## ADDENDUM NO. 1

May 12, 2022

RE: **ADDENDUM NO. 1**  
**PROJECT 000N-351**  
**PCN i6ky**  
**Stanley County**  
**Snow Fence**

Revised 5/12/22 SML

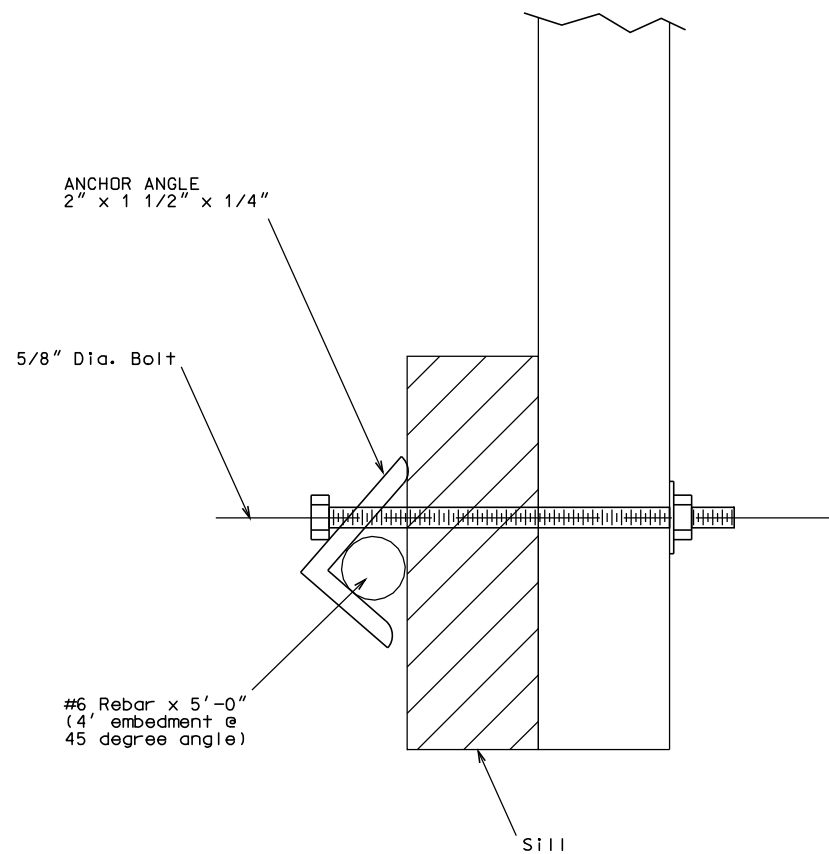
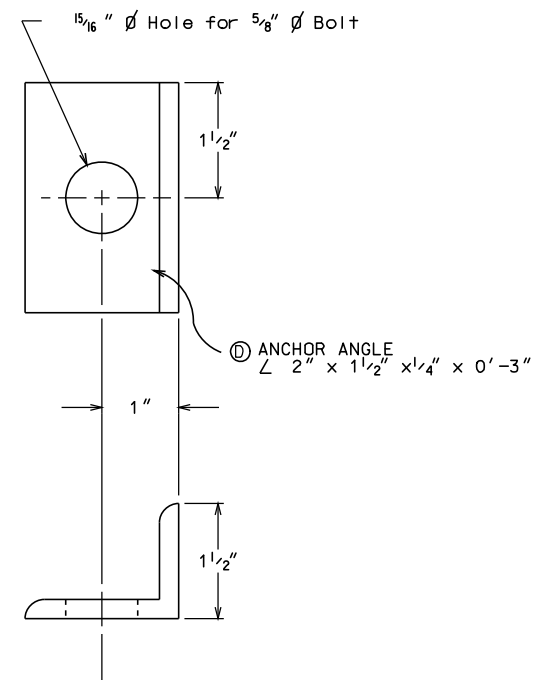
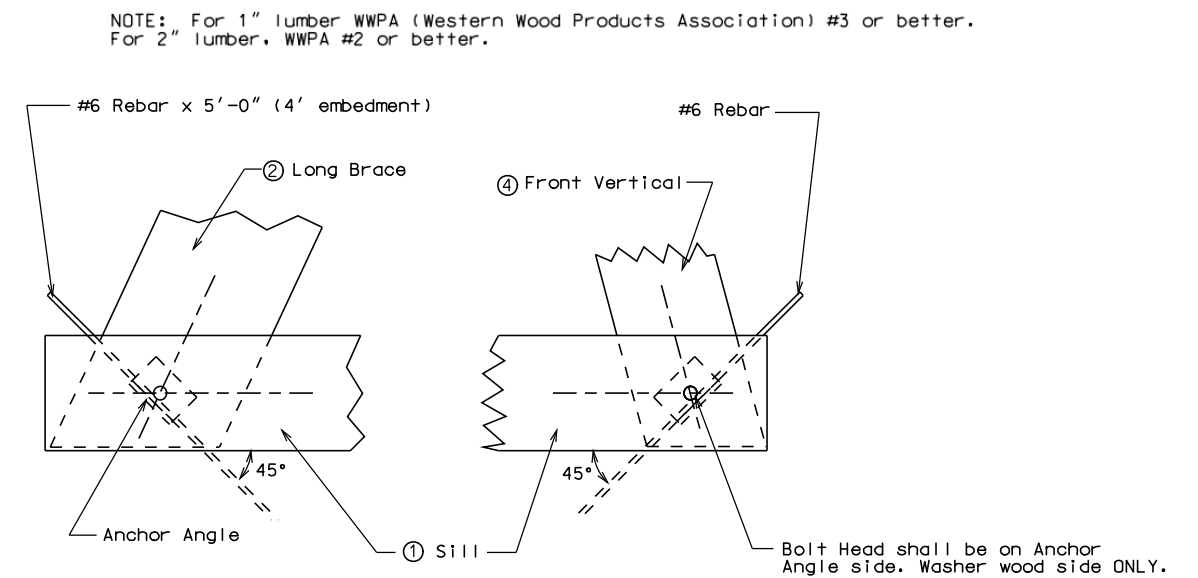
Discard the existing Sheet 10 of the plans and replace it with the enclosed Revised Sheet 10 of the plans, dated 5/12/22. The note “NOTE: For 1” lumber WWPA (Western Wood Products Association) #3 or better, and 2” lumber WWPA #2 or better.” was not shown on the original plan sheet.

NOTE: For 1" lumber WWP (Western Wood Products Association) #3 or better, and 2" lumber WWP #2 or better.
